GRANITE · FIRST CRACK

A-40-1-1091 · PLAN 09 · 81 markups in the list
Page 3 is a glance of the same list if you open this PDF without Revu.
NEED = missing info. CHECK = a note. Off-sheet shelves keep H1 / H2 / H3.

FLYGEL A - PLAN 09, DEL 1
PLANRITNINGAR

FASTIGHETSNUMMER	NUMMER	BET
0001	A-40-1-1091

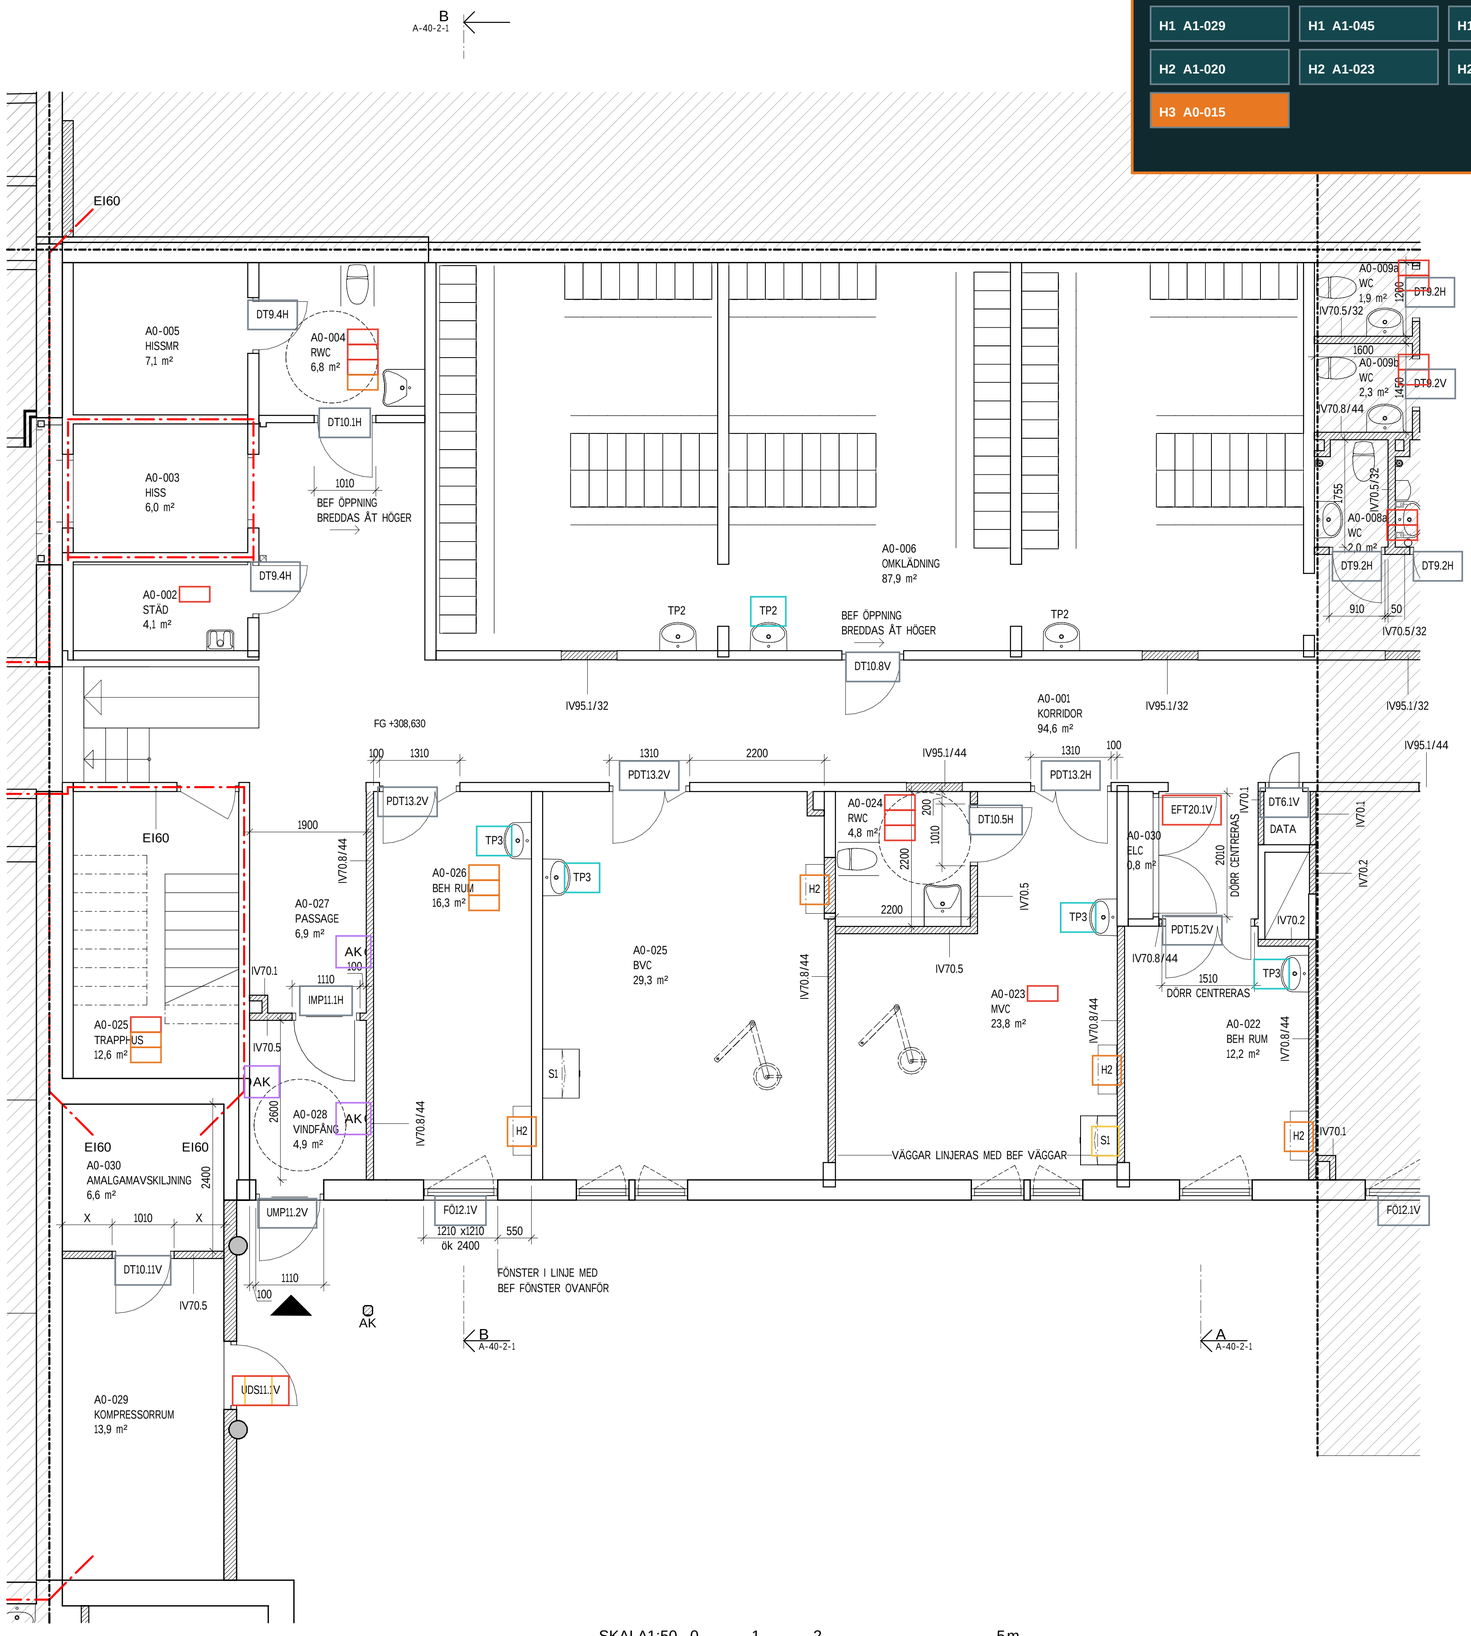
NOT ON THIS SHEET · request only · H3 is here · room A0-015 is not on PLAN 09

H1 A1-029 | H1 A1-045 | H1 A2-030 | H1 A3-035 | H2 A1-016 | H2 A1-017
H2 A1-020 | H2 A1-023 | H2 A1-039 | H2 A1-040 | H2 A1-053 | H2 A2-040
H3 A0-015

Subject	Flag	Qty	Room	Comment	What is missing / note
EFT20.1V	NEED	1	A0-030	EFT20.1V, ELC; description unavailable	The draft has a mark but no product type. Do not invent an article.
H2	NEED	1	A0-022	Hylla H2; length and specification unavailable	The floor plan marks the shelf. Length and spec are on the room description · that file
H2	NEED	1	A0-023	Hylla H2; length and specification unavailable	The floor plan marks the shelf. Length and spec are on the room description · that file
H2	NEED	1	A0-025	Hylla H2; length and specification unavailable	The floor plan marks the shelf. Length and spec are on the room description · that file
H2	NEED	1	A0-026	Hylla H2; length and specification unavailable	The floor plan marks the shelf. Length and spec are on the room description · that file
NEED	NEED	1	A0-002	Utslagsback	A sanitary symbol is drawn, but there is no type code. Need the setting-out / type stand

NEED	NEED	2	A0-004	Stödarm	A sanitary symbol is drawn, but there is no type code. Need the setting-out / type stand
NEED	NEED	1	A0-004	Tvättställ	A sanitary symbol is drawn, but there is no type code. Need the setting-out / type stand
NEED	NEED	1	A0-004	WC-stol	A sanitary symbol is drawn, but there is no type code. Need the setting-out / type stand
NEED	NEED	1	A0-008a	Tvättställ	A sanitary symbol is drawn, but there is no type code. Need the setting-out / type stand
NEED	NEED	1	A0-008a	WC-stol	A sanitary symbol is drawn, but there is no type code. Need the setting-out / type stand
NEED	NEED	1	A0-009a	Tvättställ	A sanitary symbol is drawn, but there is no type code. Need the setting-out / type stand
NEED	NEED	1	A0-009a	WC-stol	A sanitary symbol is drawn, but there is no type code. Need the setting-out / type stand
NEED	NEED	1	A0-009b	Tvättställ	A sanitary symbol is drawn, but there is no type code. Need the setting-out / type stand

NEED	NEED	1	A0-009b	WC-stol	A sanitary symbol is drawn, but there is no type code. Need the setting-out / type stand
NEED	NEED	1	A0-023	Unidentified articulated arm with circular head; product type to be confirmed	The draft has a mark but no product type. Do not invent an article.
NEED	NEED	2	A0-024	Stödarm	A sanitary symbol is drawn, but there is no type code. Need the setting-out / type stand
NEED	NEED	1	A0-024	Tvättställ	A sanitary symbol is drawn, but there is no type code. Need the setting-out / type stand
NEED	NEED	1	A0-024	WC-stol	A sanitary symbol is drawn, but there is no type code. Need the setting-out / type stand
NEED	NEED	1	A0-025	Unidentified articulated arm with circular head; product type to be confirmed	The draft has a mark but no product type. Do not invent an article.
NEED	NEED	1	·	Tvättställ, partially shown east of A0-008a	A sanitary symbol is drawn, but there is no type code. Need the setting-out / type stand

NEED	NEED	1	·	WC-stol, partially shown east of A0-008a	A sanitary symbol is drawn, but there is no type code. Need the setting-out / type stand
S1	NEED	1	A0-023	S1; description unavailable	The draft has a mark but no product type. Do not invent an article.
S1	NEED	1	A0-025	S1; description unavailable	The draft has a mark but no product type. Do not invent an article.
TP2	NEED	3	A0-006	TVÄTTPLATSUTRUSTNING	This is a package code. What is inside it comes from the type standard, which is not in
TP3	NEED	1	A0-022	TVÄTTPLATSUTRUSTNING	This is a package code. What is inside it comes from the type standard, which is not in
TP3	NEED	1	A0-023	TVÄTTPLATSUTRUSTNING	This is a package code. What is inside it comes from the type standard, which is not in
TP3	NEED	1	A0-025	TVÄTTPLATSUTRUSTNING	This is a package code. What is inside it comes from the type standard, which is not in
TP3	NEED	1	A0-026	TVÄTTPLATSUTRUSTNING	This is a package code. What is inside it comes from the type standard, which is not in

UDS11.1V	NEED	1	A0-029	UDS11.1V, KOMPRESSORRUM; description unavailable	The draft has a mark but no product type. Do not invent an article.
CHECK	CHECK	·	·	10 lines have no room (hatches, match-line items, one elbow tap).	Verify before you sign.
CHECK	CHECK	·	·	17 lines have no type code (WC, basin, support arms, unidentified arms).	Verify before you sign.
CHECK	CHECK	·	·	All 69 API lines are in this draft. The six recovered lines are other-floor request shelves,	Noted.
CHECK	CHECK	·	·	Doors, windows and metal frames are in the draft but kept out of the customer basket (other	Noted.
CHECK	CHECK	·	·	H2 is drawn, but length is not on this floor plan.	Verify before you sign.
CHECK	CHECK	·	·	Hatch quantities come from a table on the sheet, not from counting rooms.	Verify before you sign.
CHECK	CHECK	·	·	Only this PDF was uploaded. Ten other drawings, the room description and the type standard a	Verify before you sign.

CHECK	CHECK	·	·	Request-only shelves stay out of this basket: 4× H1, 8× H2, 1× H3 (A0-015). They stay on the	Noted.
CHECK	CHECK	·	·	S1, EFT20.1V, UDS11.1V and two articulated arms have no product type.	Verify before you sign.
CHECK	CHECK	·	·	TP3 / TP2 are package codes. Contents need the type standard.	Verify before you sign.
CHECK	CHECK	·	·	The customer asked for H2. The old specialist quote never listed H2.	Verify before you sign.
CHECK	CHECK	·	·	The four H2 rooms in the email are on this plan (A0-022, 023, 025, 026).	Noted.
AK	On sheet	1	A0-027	ARMBÅGSKONTAKT	Elbow tap is drawn. Confirm article and whether it belongs in this fittings quote.
AK	On sheet	2	A0-028	ARMBÅGSKONTAKT	Elbow tap is drawn. Confirm article and whether it belongs in this fittings quote.
AK	On sheet	1	·	ARMBÅGSKONTAKT outside entrance	Elbow tap is drawn. Confirm article and whether it belongs in this fittings quote.
IL.4	On sheet	2	·	HILA Inspektionslucka 300x300 mm	From the hatch table on this sheet, not counted on the floor.
